**SUBJECT:** Work Session for P13-2078

**APPLICANTS:** SummerHill Apartment Communities

**PURPOSE:** Work Session to review and receive comments on a Preliminary Review application to demolish the existing office building and construct 177 apartment units and related site improvements on a 5.9-acre site

**LOCATION:** 5850 West Las Positas Boulevard

Proposed Site Plan

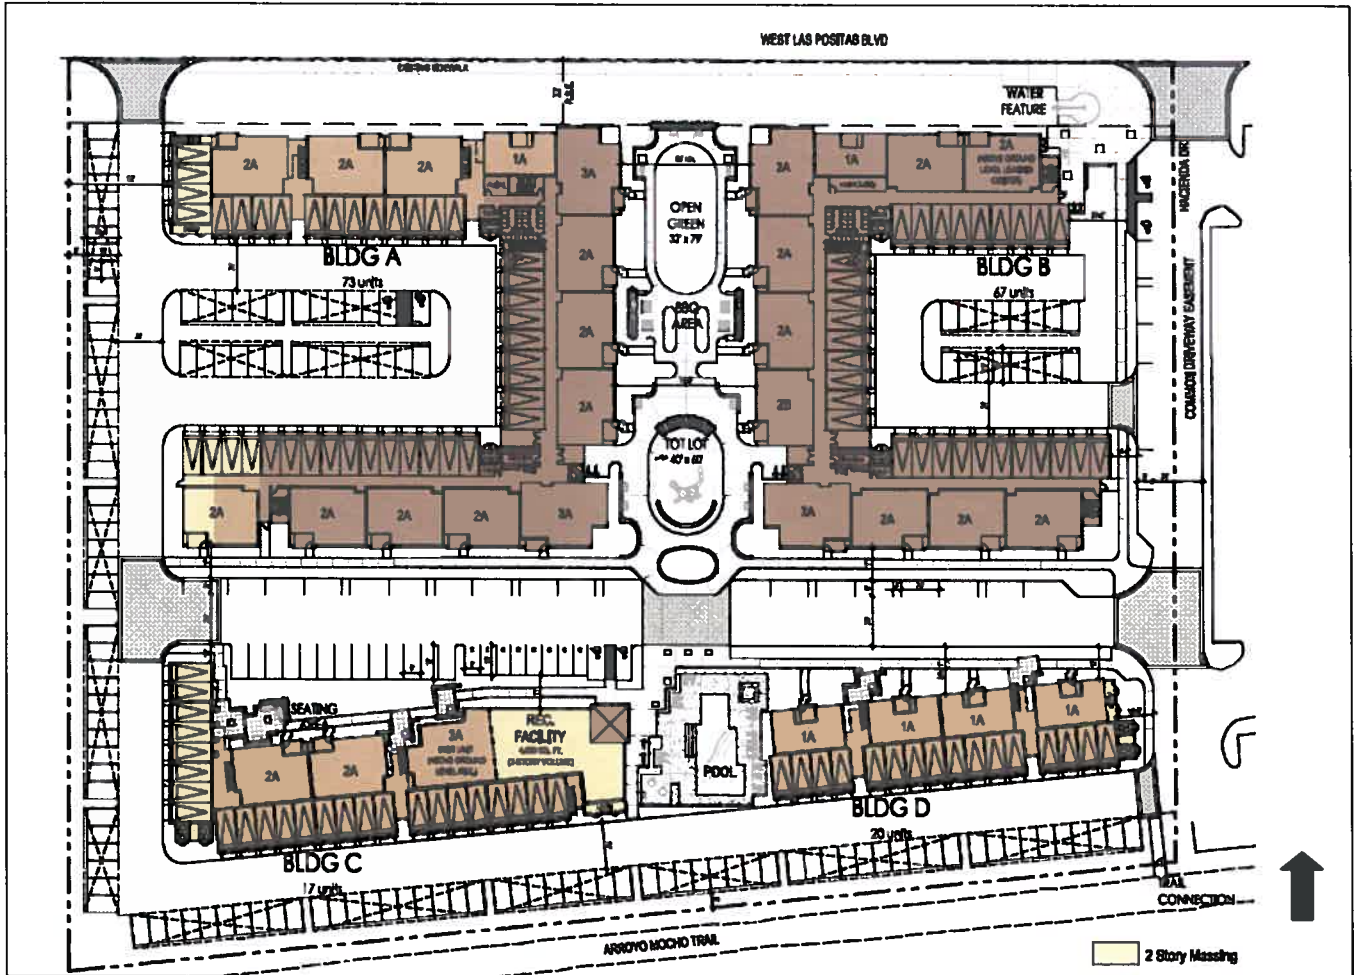
1. Provide building entries for Buildings A and B that face West Las Positas Boulevard.

2. Enhance the building entries so that they become a prominent feature of the front façade and identify access to individual units.

3. Provide both landscape screening and fencing between the subject development and the adjacent commercial development to the west.

4. Provide low walls and landscaping to screen parking at the northwest corner of the site.

1. The carports would be located eight feet from the western property line. The applicant could remove carport parking along the western property line and still conform to the requirement of providing one covered parking space per residential unit. The applicant prefers to keep the carports. Staff suggested that the applicant discuss the proposed carport location with the adjacent property owners to the west to determine if they would object and/or request alternative mitigation.

2. The existing western entrance would serve as one of the two entrances to the proposed development. It should, like the eastern entrance, be designed as an internal street. Sheet A1.2 shows it is designed as an alley.

**Site Plan.** As proposed, the buildings meet the setback requirements. The site plan shows a feathering of densities with the lowest densities by the Arroyo Mocho and adjacent one-story commercial development and that stories above the second story on the west elevation are stepped back. The project's main entrance would be from the eastern edge of the site at the existing signalized intersection at West Las Positas Boulevard and Hacienda Drive. The applicant will provide building entries for Buildings A and B that face West Las Positas Boulevard to meet the Design Guidelines requirements. Staff believes that a pedestrian connection needs to be provided between West Las Positas Boulevard to the proposed open space area.
